# Addendum 64: Regulation No. 65

#### **Revision 2 – Amendment 1**

Uniform provisions concerning the approval of special warning lamps for power-driven vehicles and their trailers

### "Annex 2

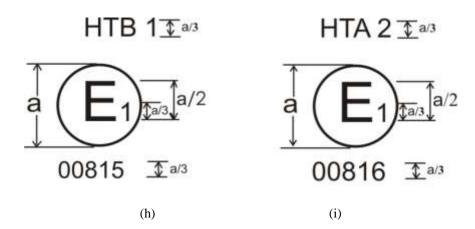
*Insert new examples of approval marks (h) and (i),* to read:

- (h) A half bar of a special warning lamp indicates that it has been approved in Germany (E1) under approval number 00815. The approval number shows that the approval was granted in accordance with the requirements of the Regulation in its original form and that it is a blue rotating or stationary flashing special warning lamp of class 1 (HTB 1).
- (i) A half bar of a special warning lamp indicates that it has been approved in Germany (E1) under approval number 00816. The approval number shows that the approval was granted in accordance with the requirements of the Regulation in its original form and that it is a amber rotating or stationary flashing special warning lamp of class 2 (HTA 2)."
